UNITED STATES PATENT AND TRADEMARK OFFICE

Office Action Summary	Application No. 10/539,102	Applicant(s) LANKHORST ET AL.	
	Examiner Jami M. Valentine, Ph.D.	Art Unit 2815

DETAILED ACTION

Prior Art: Cohen Figure 1

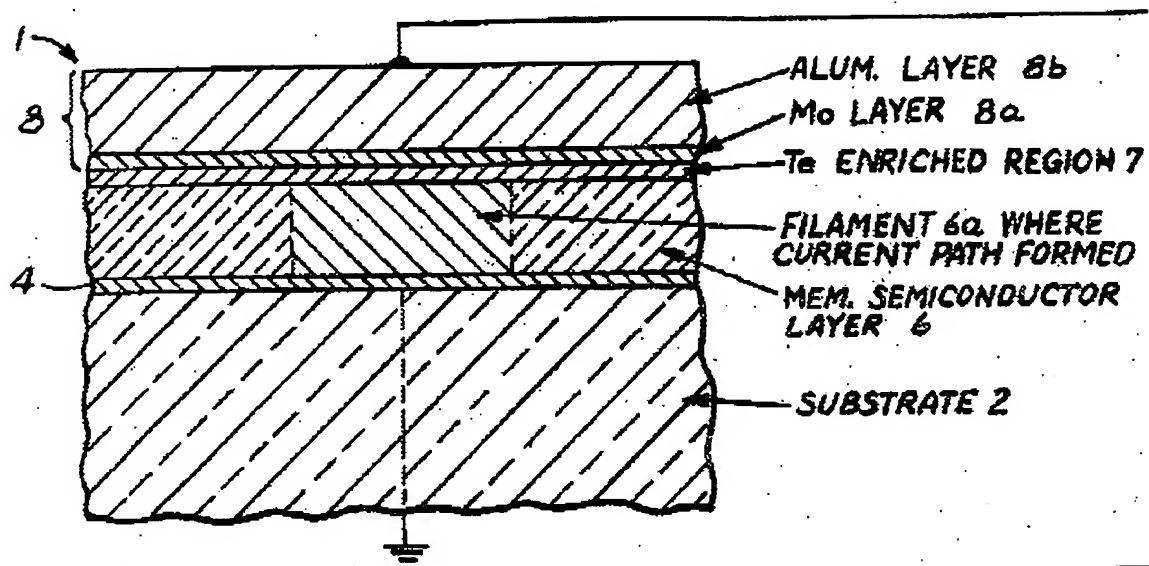
15. Per **Claim 1** Cohen (figure 1) discloses a device including a body having

- a resistor comprising a phase change material (6) being changeable between a first phase and a second phase, the resistor having a first electrical resistance when the phase change material is in the first phase and a second electrical resistance, different from the first electrical resistance, when the phase change material is in the second phase, (column 1 lines 56-60)

- a heating element (6a) being able to conduct a current for enabling a transition from the first phase to the second phase, the heating element being arranged in parallel with the resistor. (column 1 lines 64-67)

17. Per **Claim 2**, insofar as definite, the claim is interpreted for examination in view of the existing prior art as follows: Cohen discloses the device of claim 1, including where the heating element has a heating element electrical resistance which is smaller than the maximum of the

first electrical resistance and the second electrical resistance. (figure 1 teaches that the current path is formed in the heater (filament (6a)). Hence the reference inherently discloses that the resistance of the heating element is smaller than the maximum of the first electrical resistance and the second electrical resistance, otherwise the current path would be formed in the phase change material)

18. Per **Claim 4** Cohen (figure 1) discloses the device of claim 1 including where the heating element and the resistor are in direct contact.
